Project: **Monroe Ave. Area Main
Replacements**

CWO No.: **03-120**

Addendum No. 1

ADDENDUM 1: PAGE 1 OF 2
 REFERENCE SHEET D-7: ADDITION OF 15 L.F. 8" PVC WATER MAIN, ABANDONMENT OF EXISTING WHARFHEAD FIRE HYDRANT, INSTALLATION OF ONE JONES J-3740 FIRE HYDRANT, ADDITION OF 390 SQ. FT. TYPE II SLURRY SEAL.

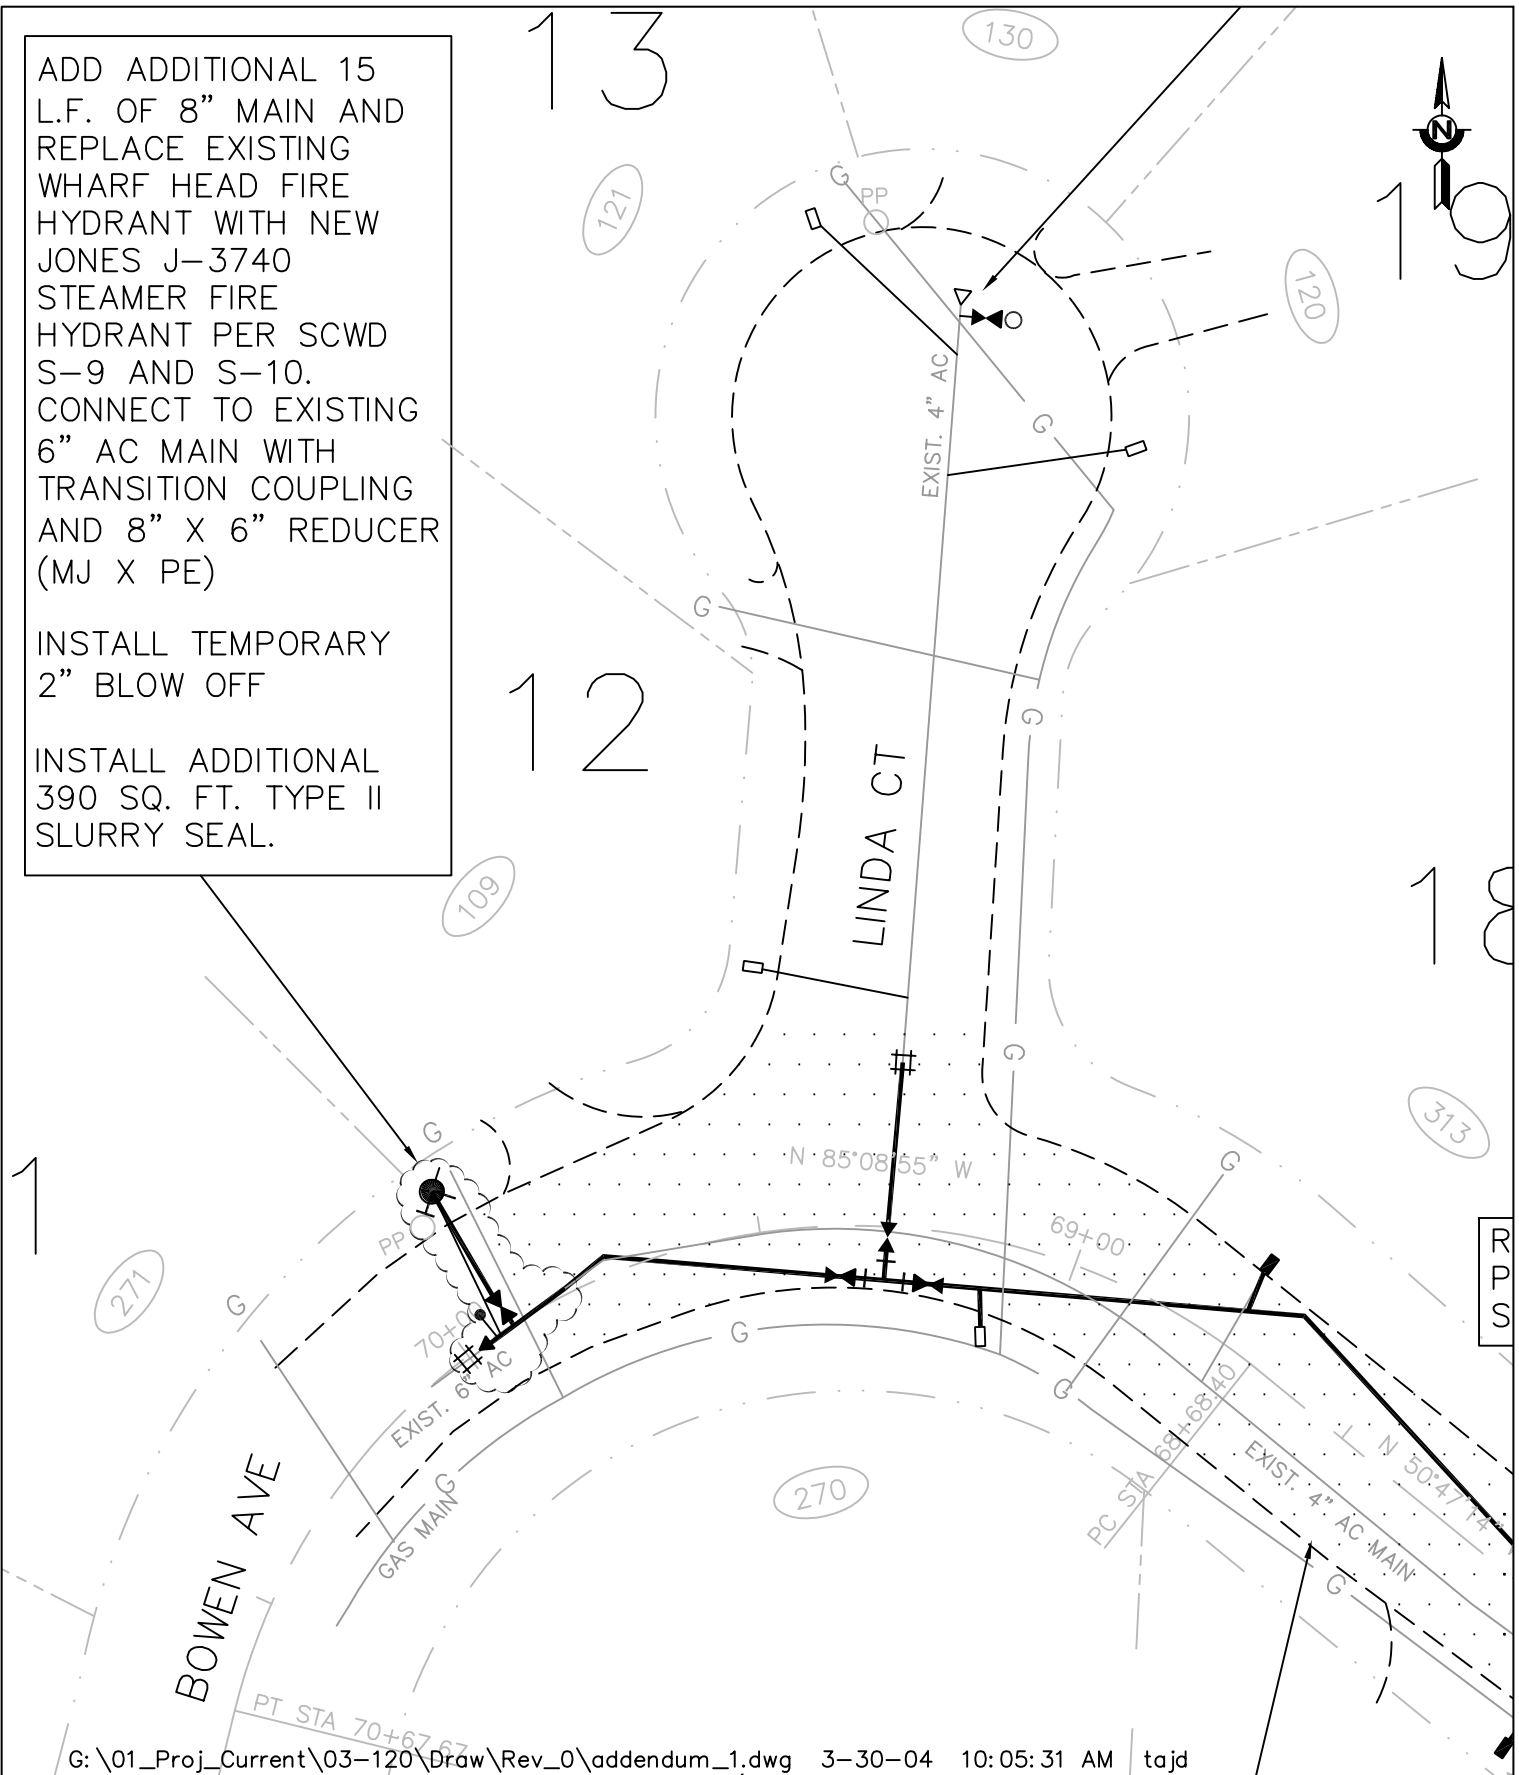
- Reference Sheet D-7 and attached sheet 1 of 2: The Contractor shall bid to install an additional 15 lineal feet of 8-inch PVC main line and abandon an existing wharf head fire hydrant and install a new Jones J-3740 fire hydrant per SCWD S-9 & S-10. An additional 390 sq. ft. of type II slurry seal will also be required. Reference attached sheet 1 of 2. The Contractor shall use the attached REVISED PROPOSAL FORM.

ADD ADDITIONAL 15 L.F. OF 8" MAIN AND REPLACE EXISTING WHARF HEAD FIRE HYDRANT WITH NEW JONES J-3740 STEAMER FIRE HYDRANT PER SCWD S-9 AND S-10. CONNECT TO EXISTING 6" AC MAIN WITH TRANSITION COUPLING AND 8" X 6" REDUCER (MJ X PE)

INSTALL TEMPORARY 2" BLOW OFF

INSTALL ADDITIONAL 390 SQ. FT. TYPE II SLURRY SEAL.
